Revision since Section 19 drawings issued on P03 12.09.26:

Project Title:
South Tyneside College - Listed Building

Drawing Title:
Internal Door Elevations

Dwg No: CAS015-GSSA-LB-XX-DR-A-3110 Rev: C06

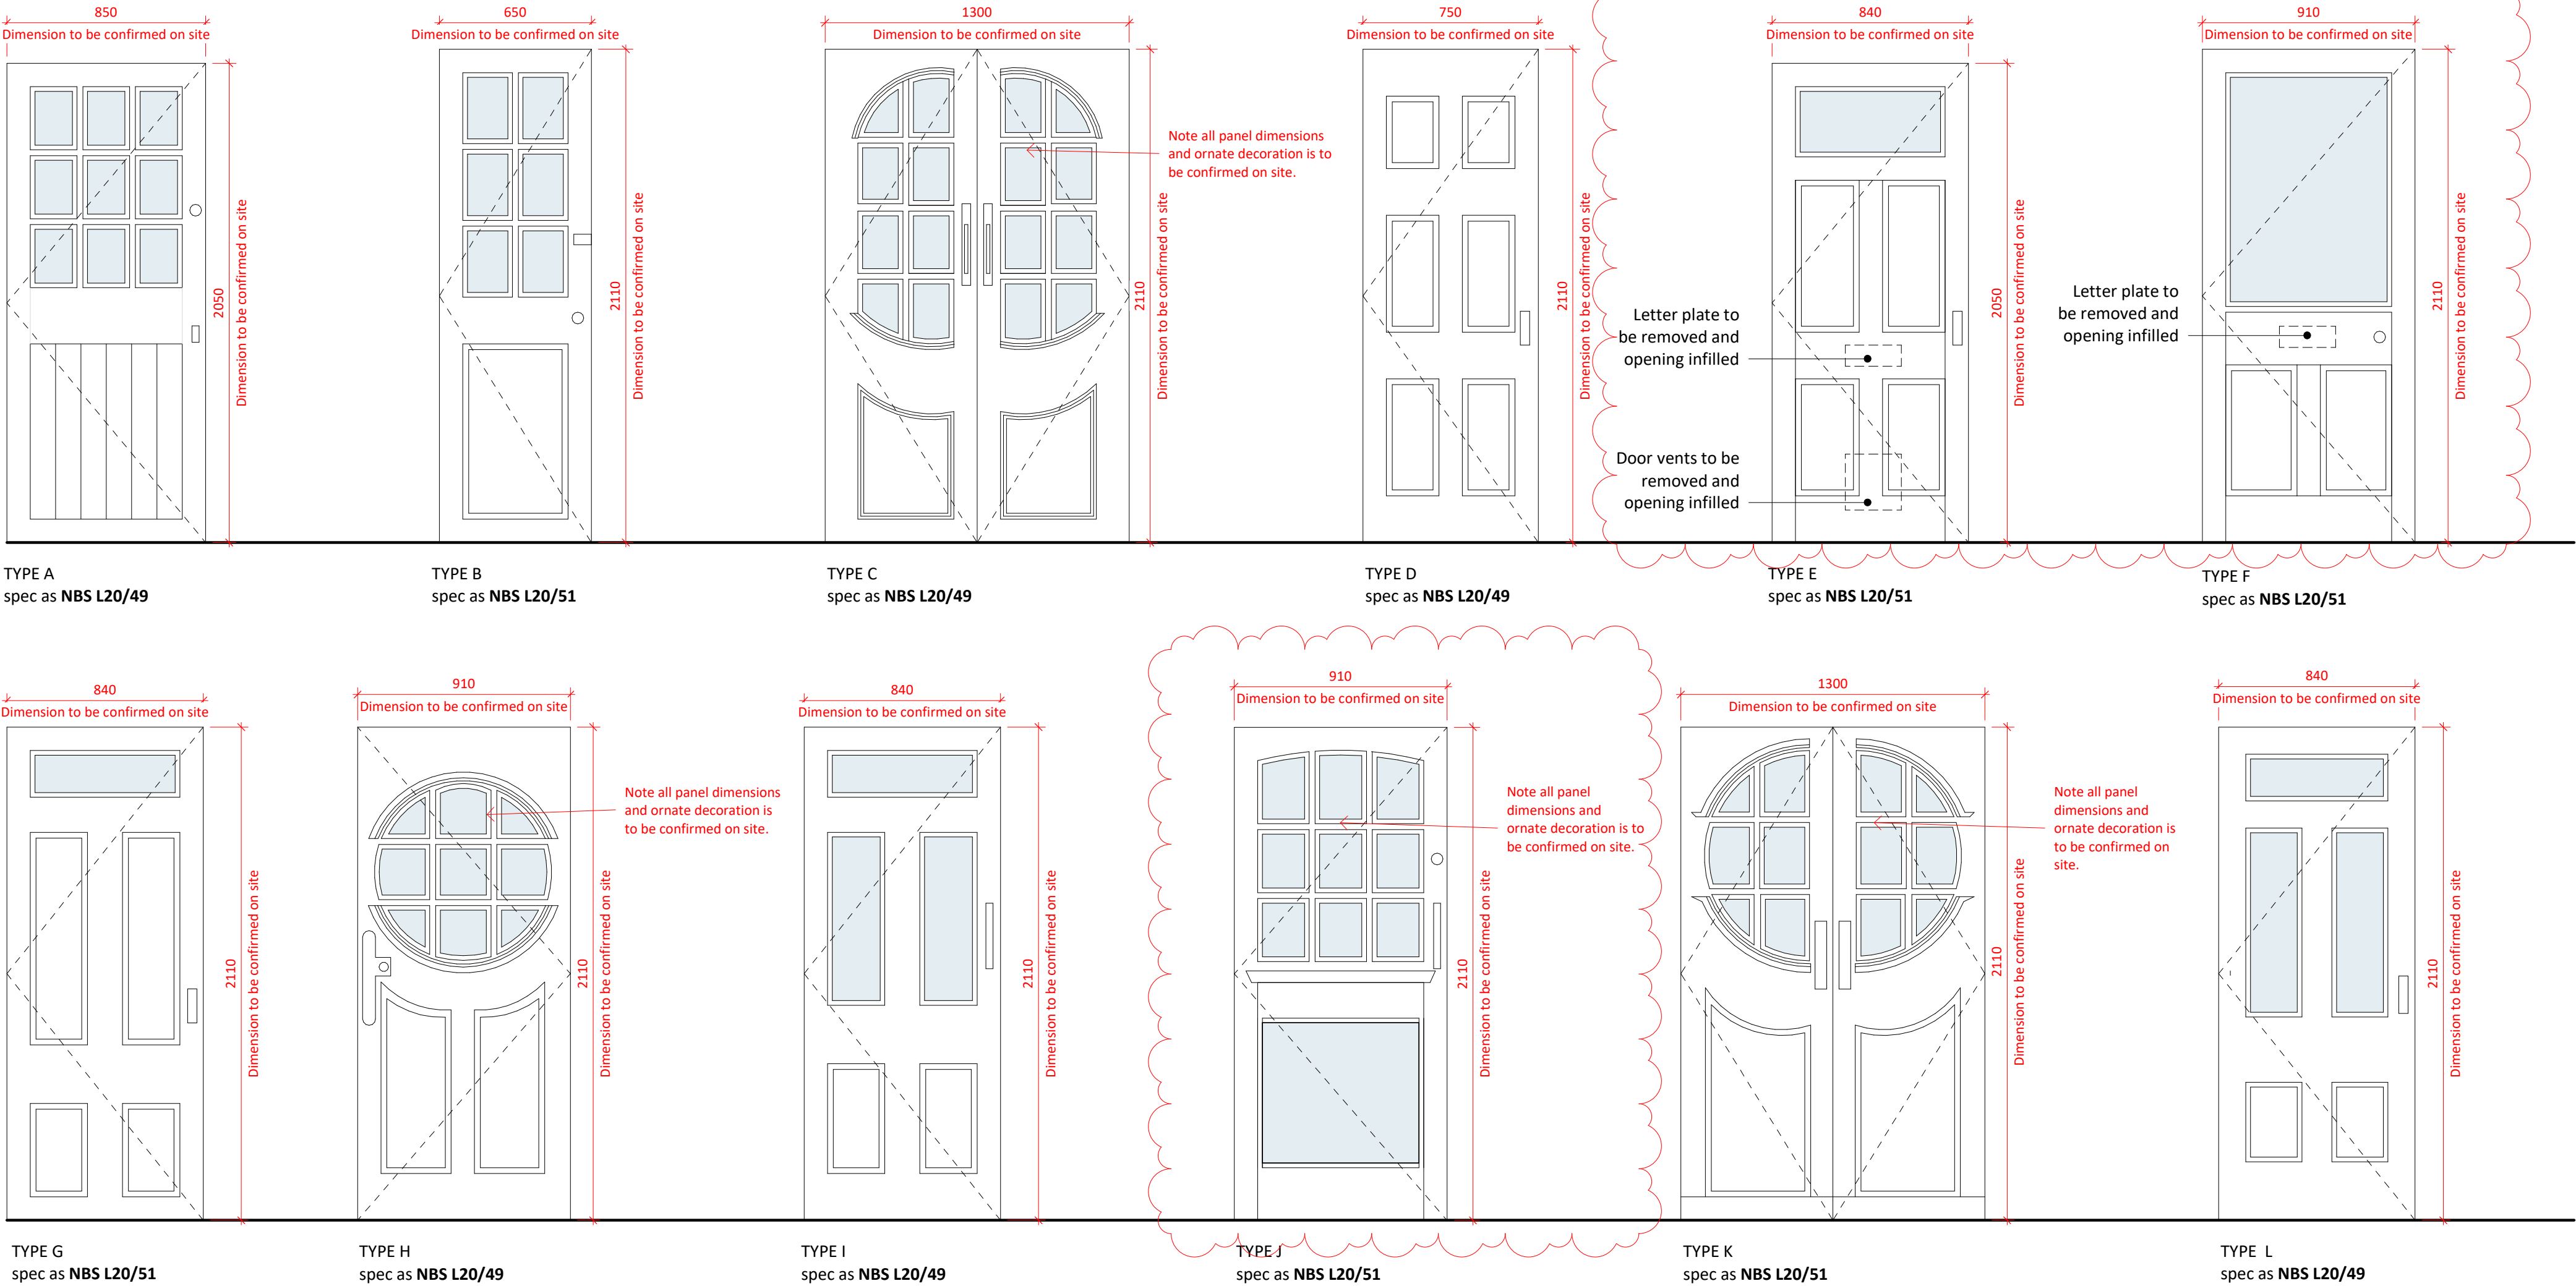
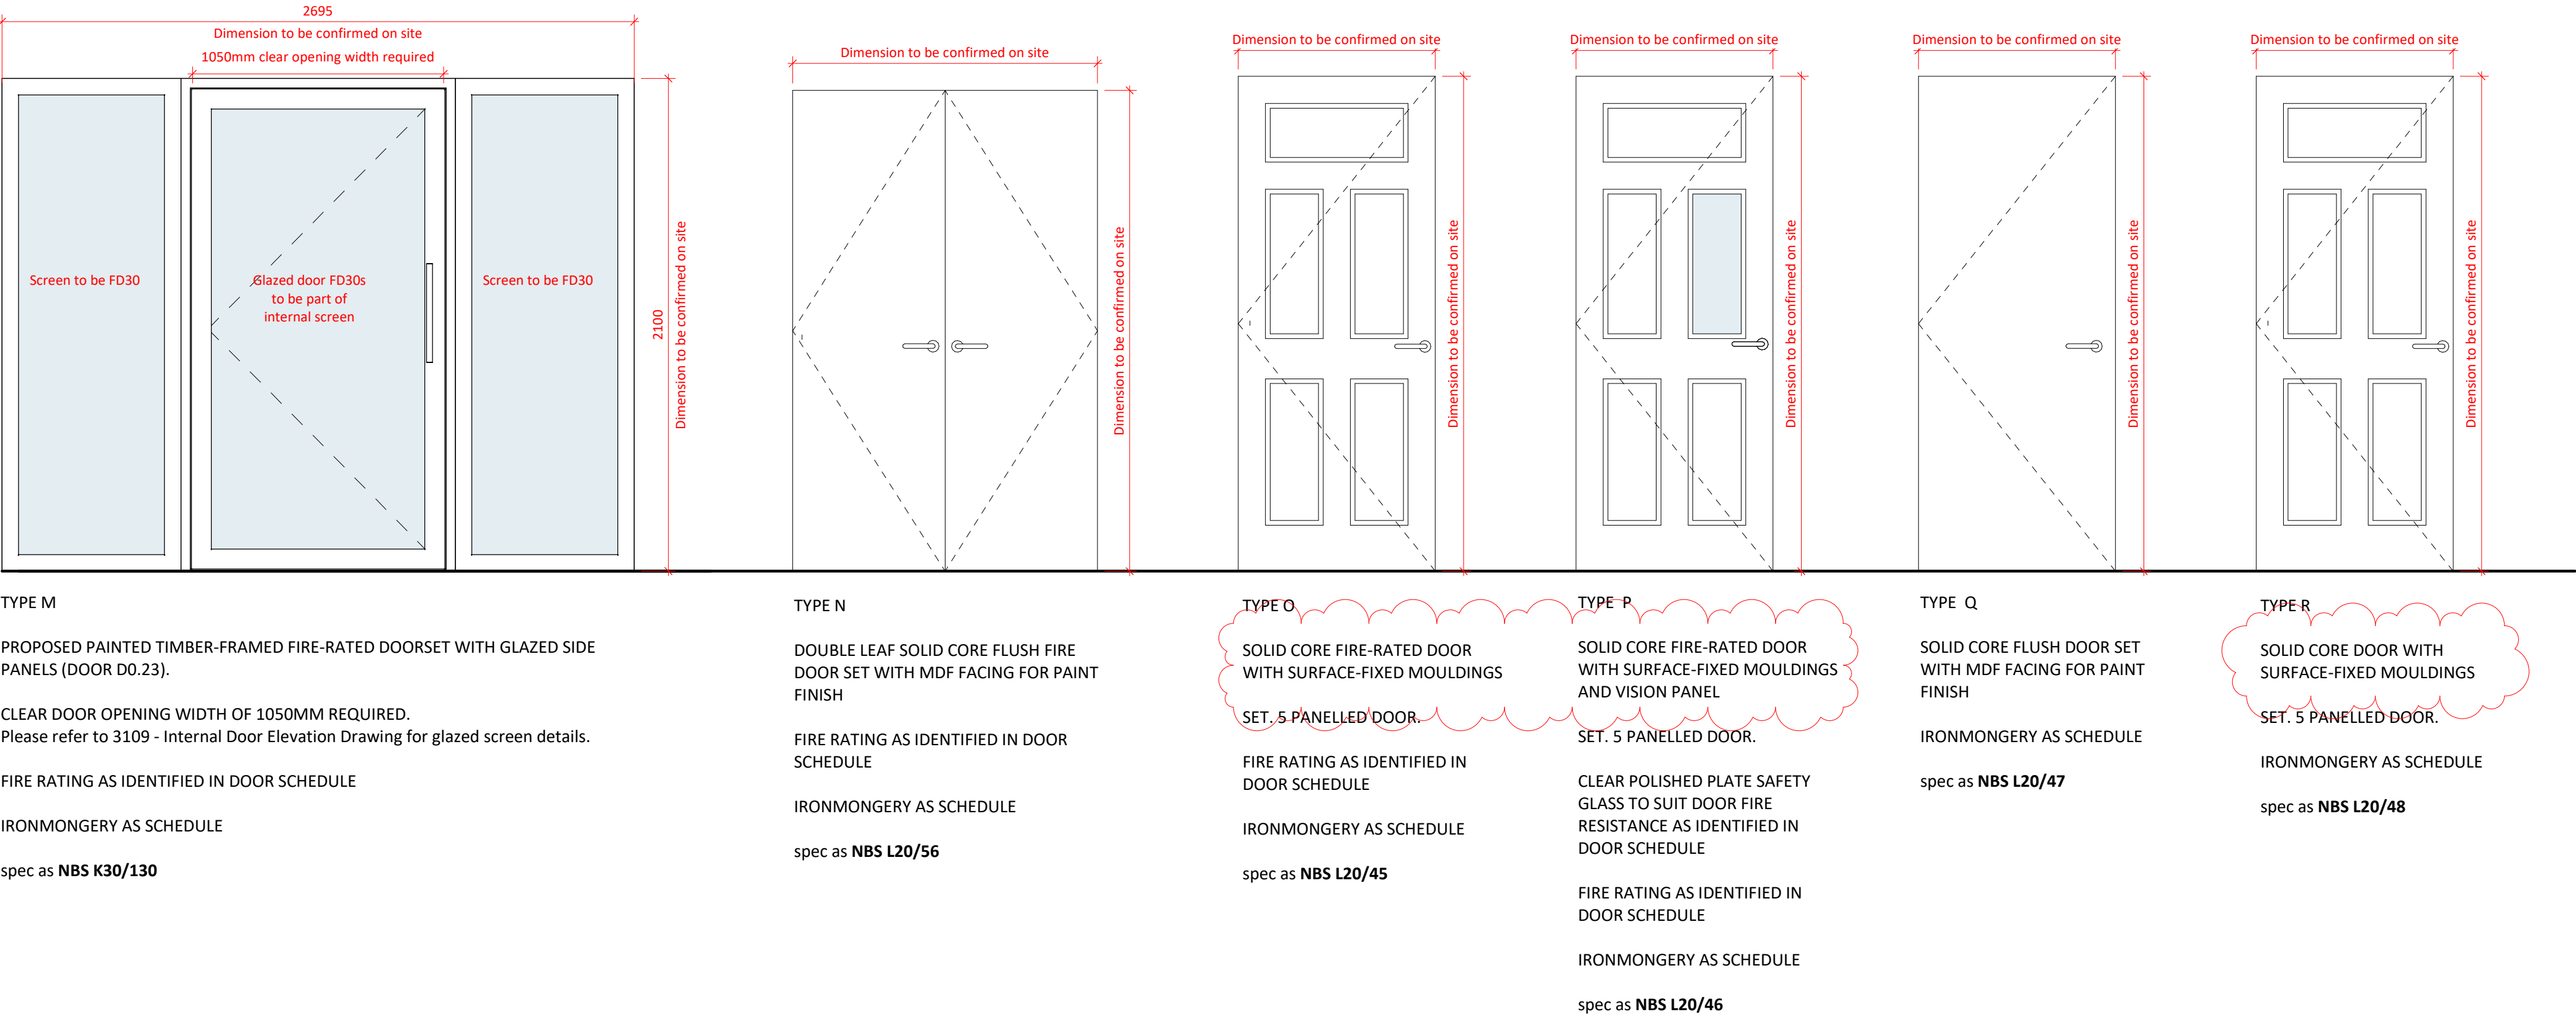
Retained Doors

- Addition of door details (letterboxes, door vents, and panels) for retained historic doors: Types E, F, and J.

Proposed Doors

- Types O, P, and R:
- Construction revised from mortice-and-tenon construction to solid-core construction with surface-mounted mouldings.

Ironmongery

- Revision to ironmongery finishes:
 - New ironmongery on doors with retained historic ironmongery to be Antique Brass.
 - New ironmongery on all other doors to be Satin Stainless Steel (brushed finish).

- Revision to the access control system:
 - AFusion element changed to SALTO XS4 integrated handle system.
 - Access control to be provided on new doors only.

Door Treatment System

- Added details of the proposed door paint system methodology.
- Included the paint system methodology (Envirograf intumescent coating) for retained doors being upgraded to achieve FD30s fire performance.
